MUKILTEO FERRY TERMINAL (PHASE 2) FERRY TERMINAL CONSTRUCTION

VOLUME 3 OF 8

VOLUME 3 SHEET INDEX - CONT

FILE NAME: PW:\WSF\Mukilteo\14W121_FerryTermConst\CADD\KPFF\18w121io00.09.dlv										 Washington State Department of Transportation WASHINGTON STATE FERRIES	/ /2017	SR 525 MUKILTEO FERRY TERMINAL (PHASE 2) FERRY TERMINAL CONSTRUCTION	10.09														
PRINTED: 9:19:32 AM 1/11/2019	LAST PRINTED BY: R. JACKSON				FED.AID PROJ.NO.	WA-2017-007-00	REGION NO. STATE 10 WASH	JOB NUMBER 18W121	CONTRACT NO. 00****					SHEET 10 OF 1521 SHEETS													
													SUBMITTAL DATE: 1/18/19		DESIGNED BY: A. GASTINEAU	1/18/19	ENTERED BY: R. JACKSON	1/18/19	CHECKED BY: D. ALIRE	1/18/19	MAR PROJ ENGR: C. TORRES	DIR TERM ENGR: N. MCINTOSH	ASST SECRETARY: A. SCARTON	CONFORMED PLANS REVISION	1/18/19	DATE	BY

RFI 121 - T-Mullion and HSS Base Plate Conflict

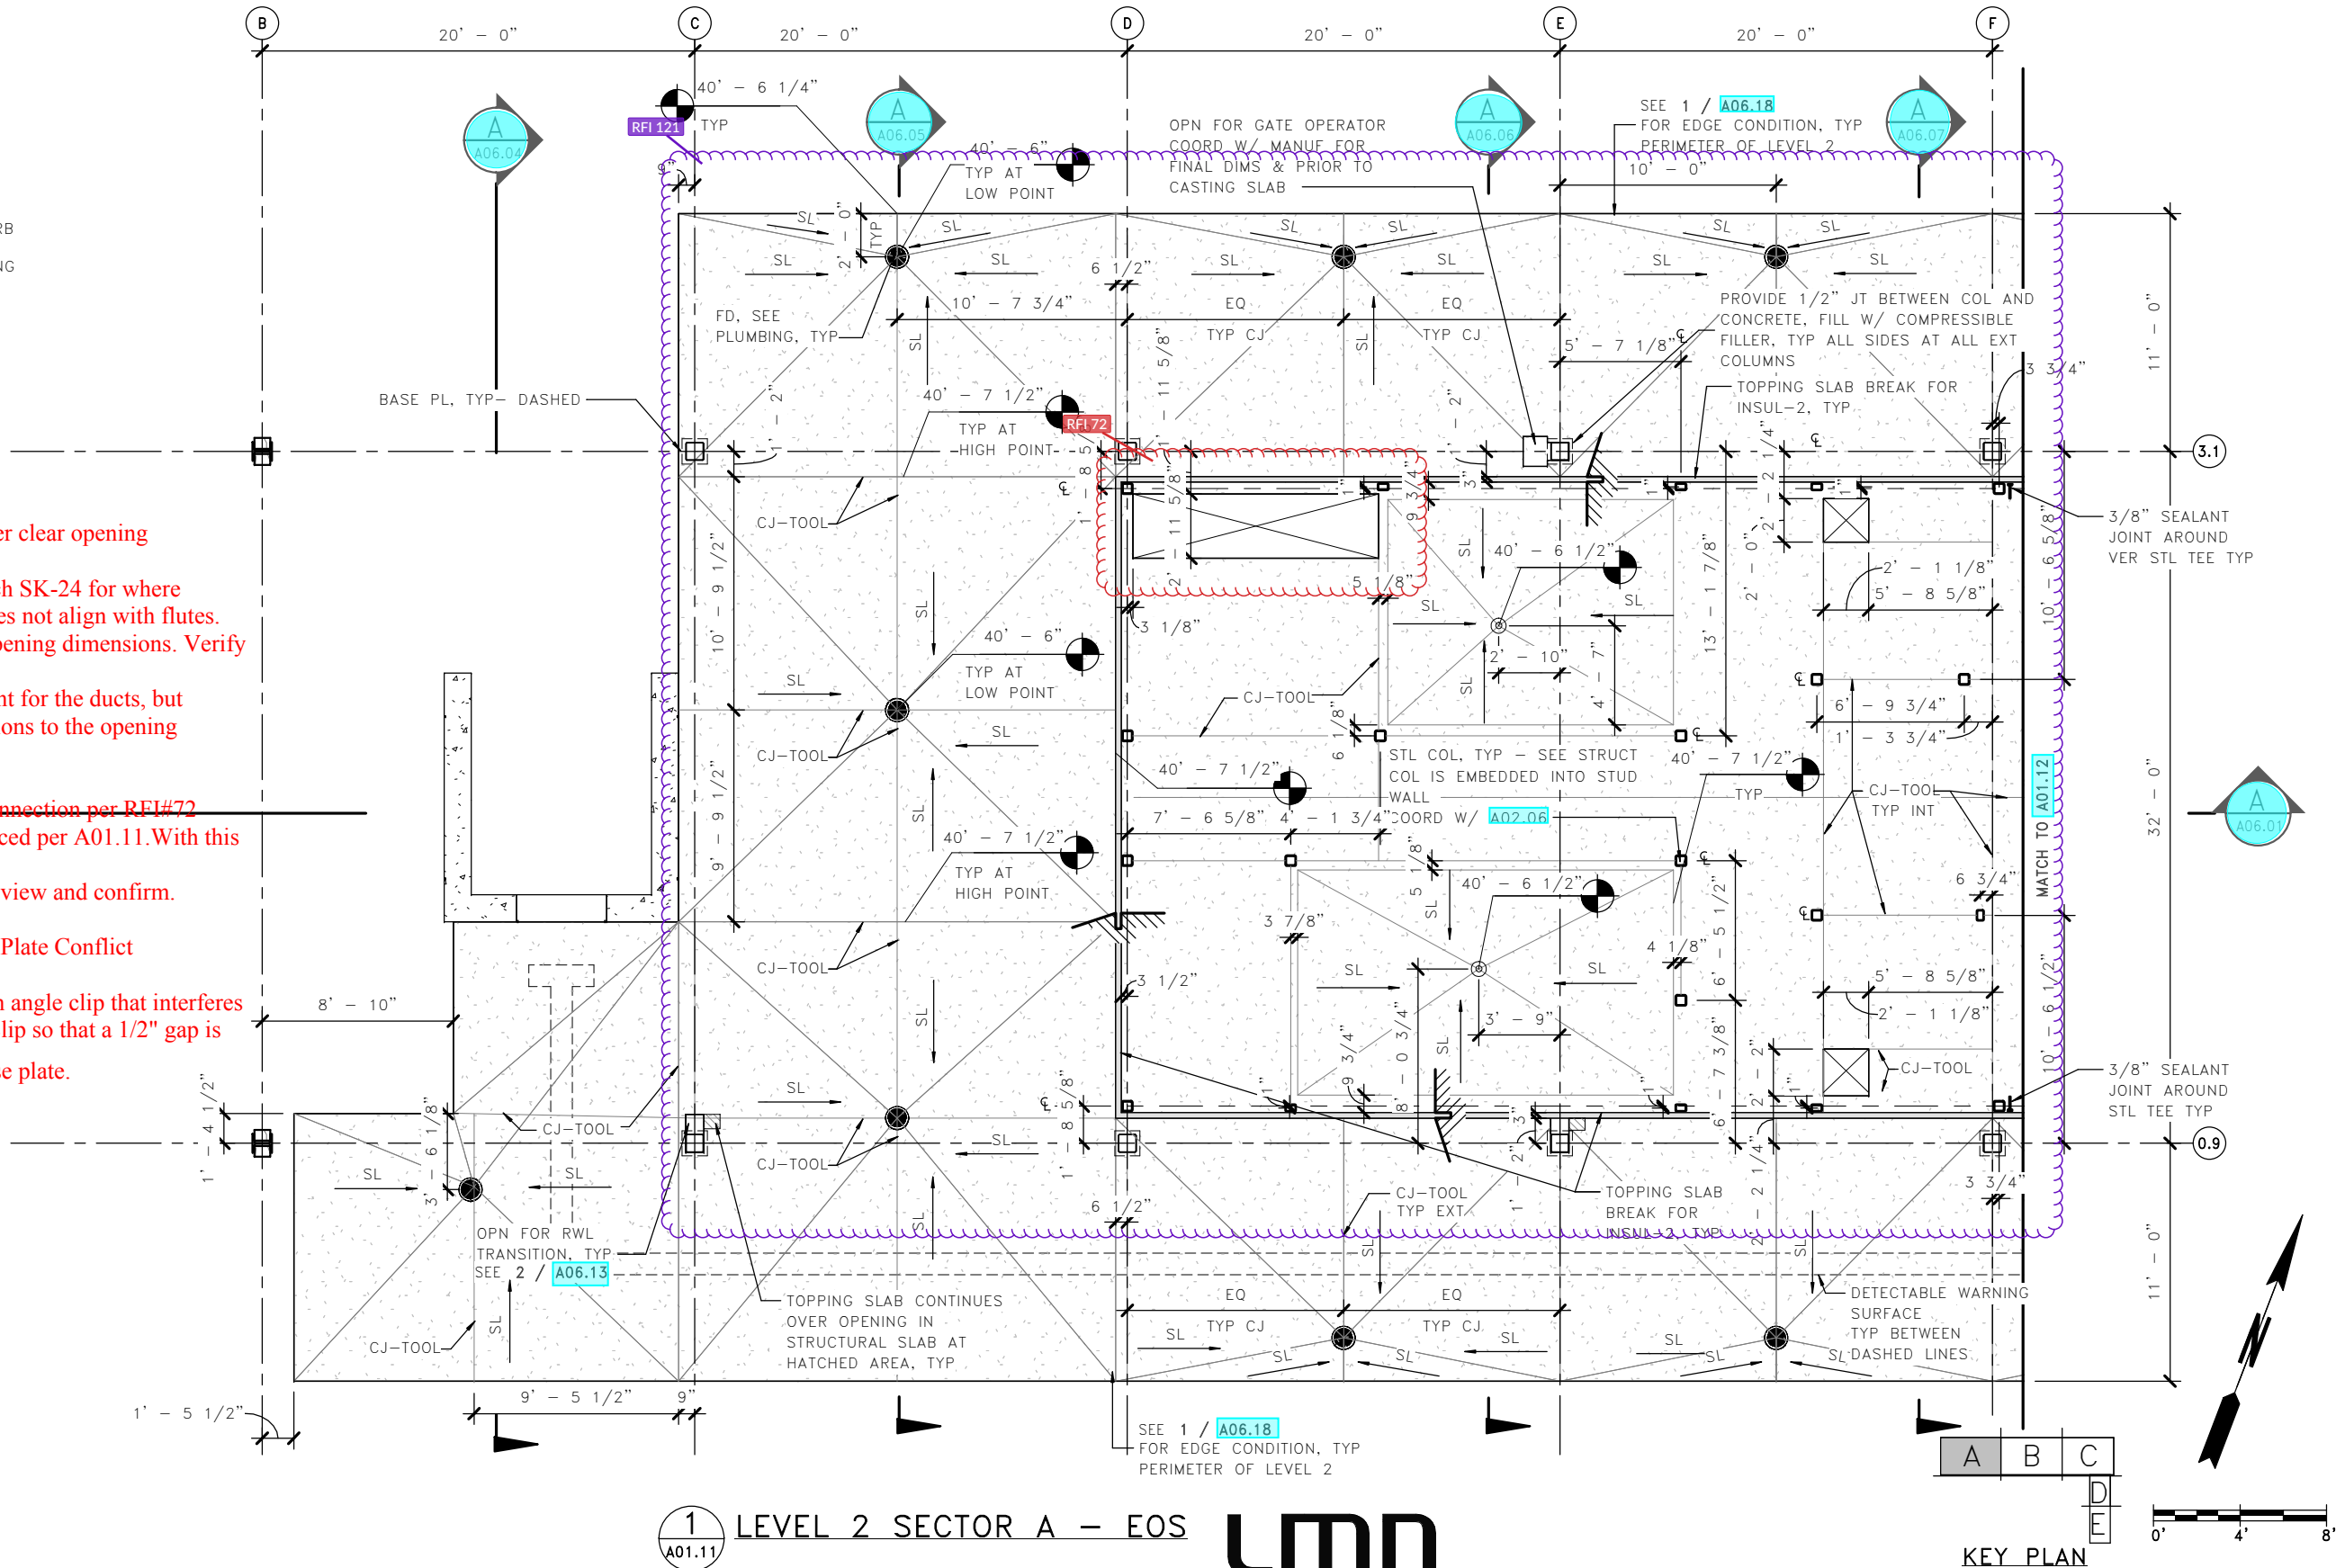
We have updated HSS base plate connection per RFI#72 response. The horizontal beam is placed per A01.11. With this we are unable to maintain the clear opening of 2'-11 5/8". Please review and confirm.

It is acceptable to trim the T-mullion angle clip that interferes with the base plate. Trim the angle clip so that a 1/2" gap is provided between angle clip and base plate.

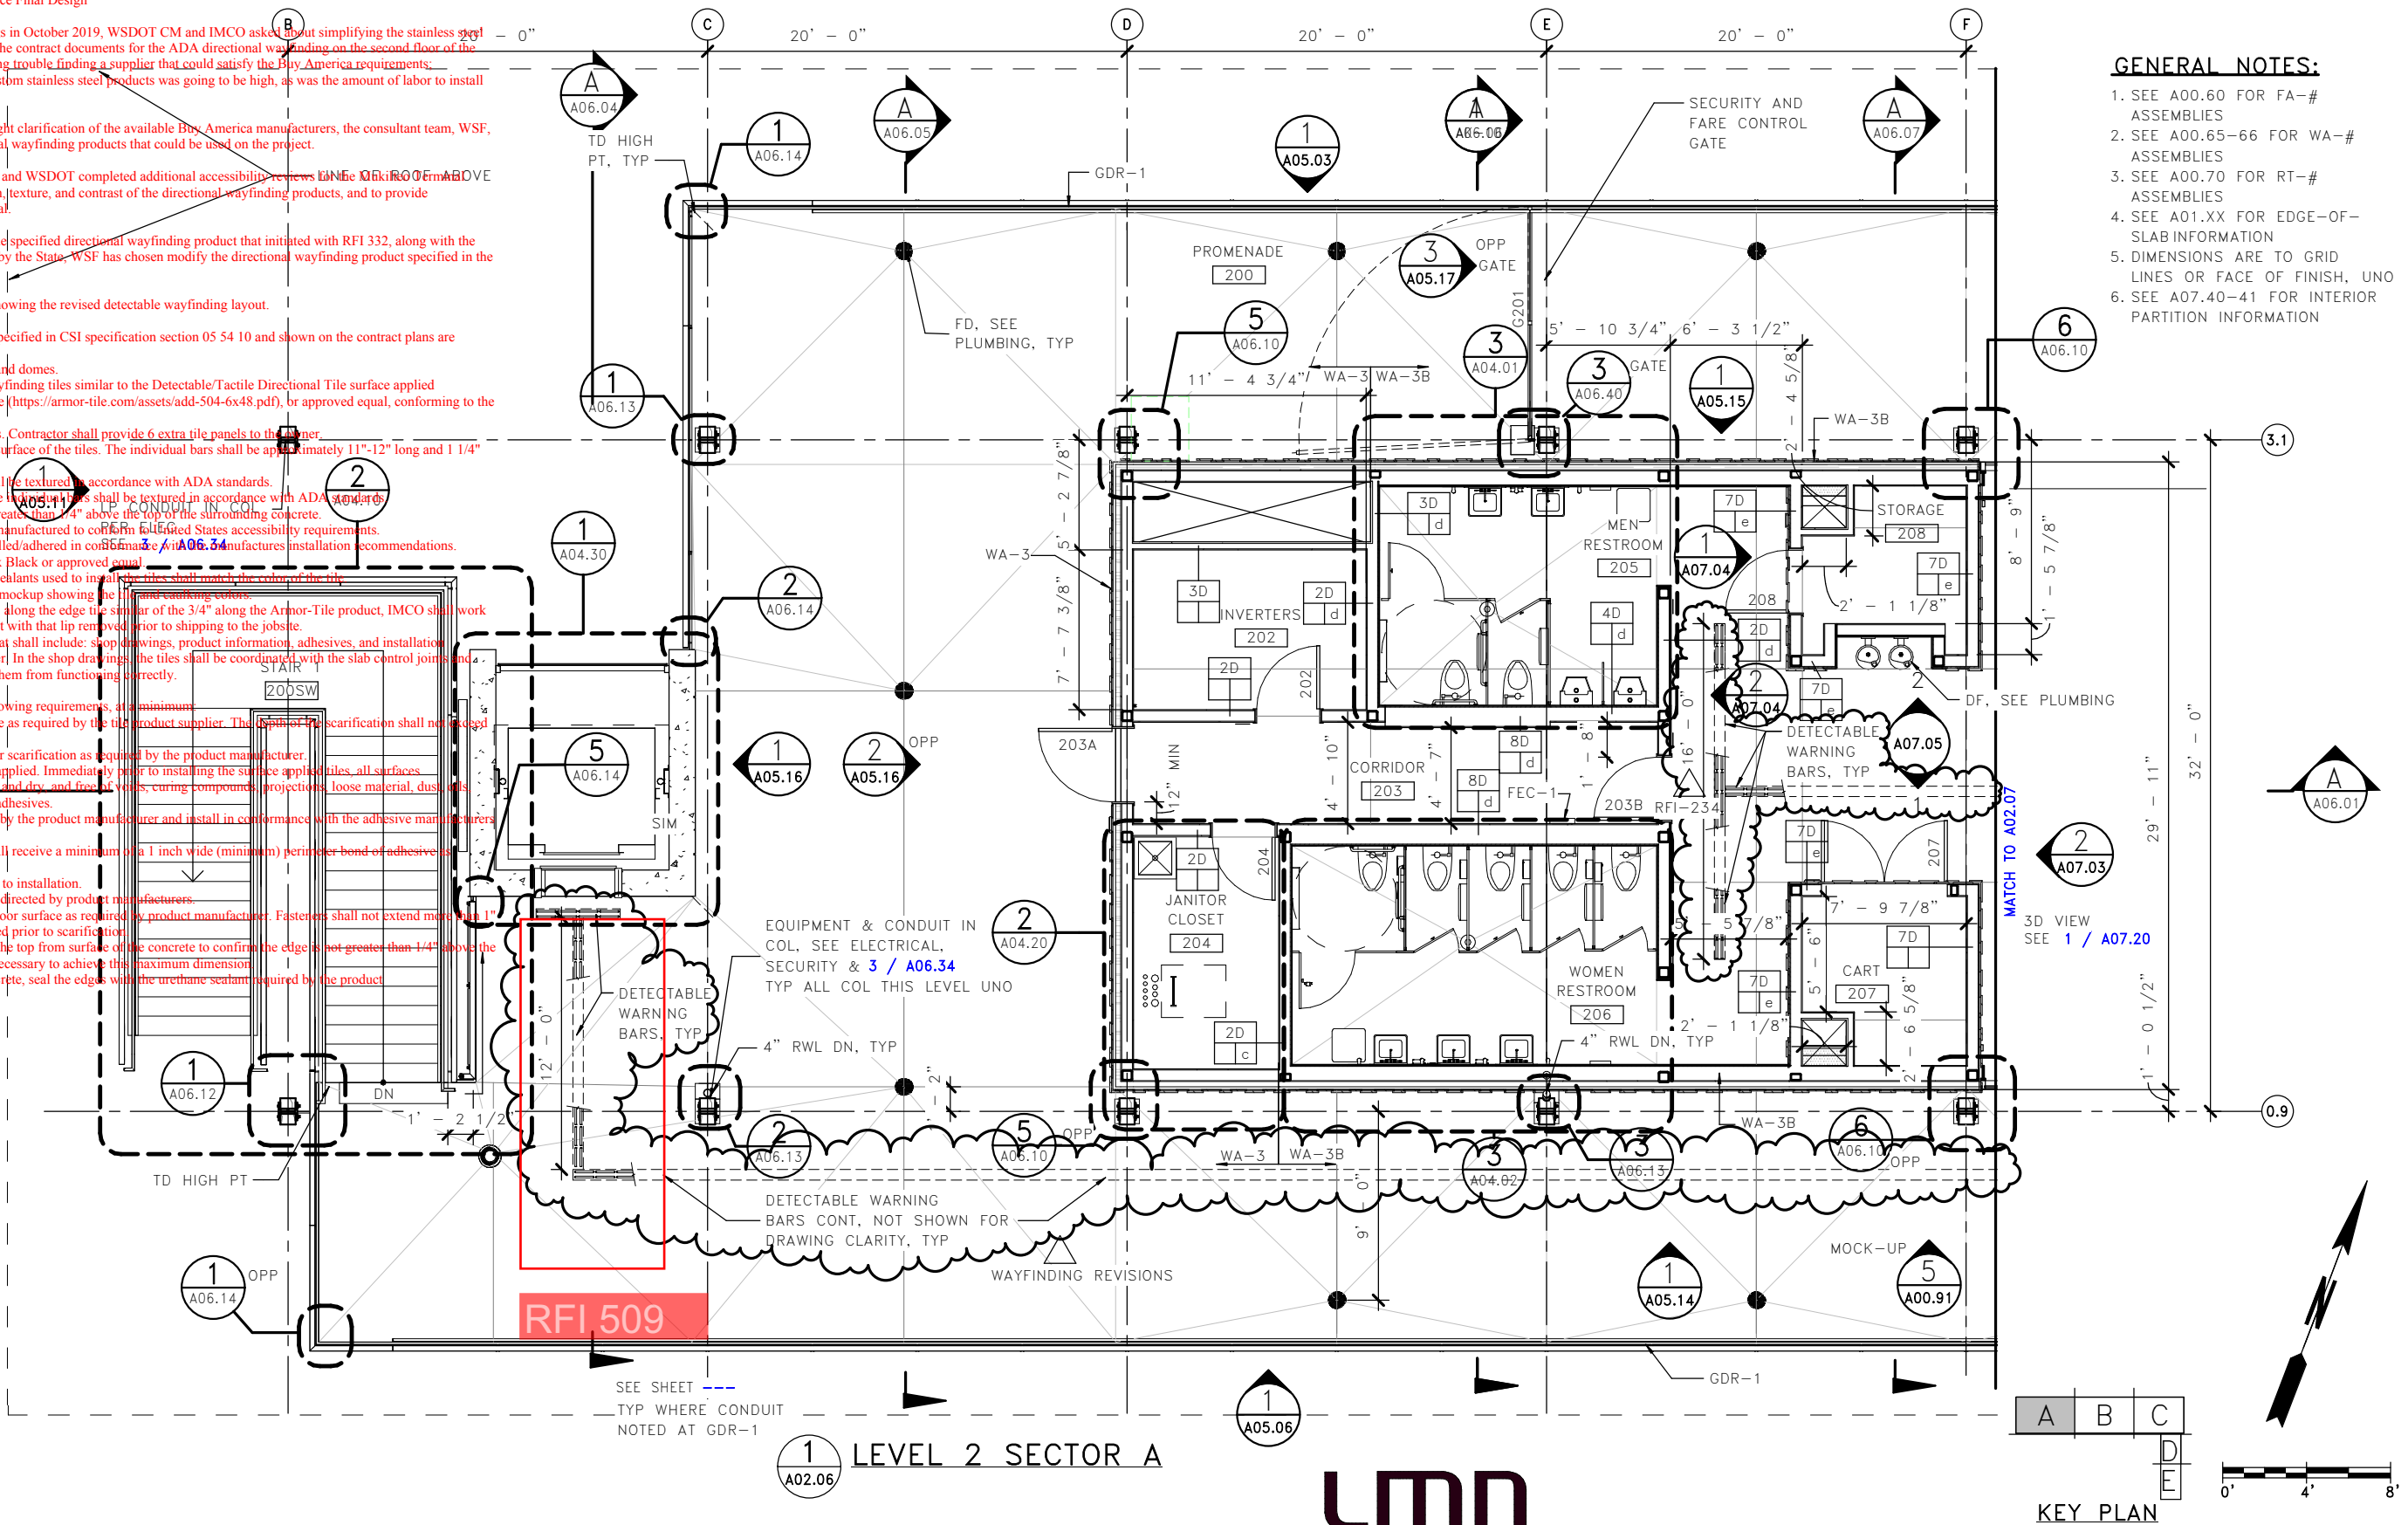
The stainless steel bars and domes specified in CSI specification section 05 54 10 and shown on the contract plans are revised as follows:

1. Eliminate the stainless steel bars and domes.
2. Provide composite directional wayfinding tiles similar to the Detectable/Tactile Directional Tile surface applied product manufactured by Armor-Tile (<https://armor-tile.com/assets/add-504-6x48.pdf>), or approved equal, conforming to the following requirements:
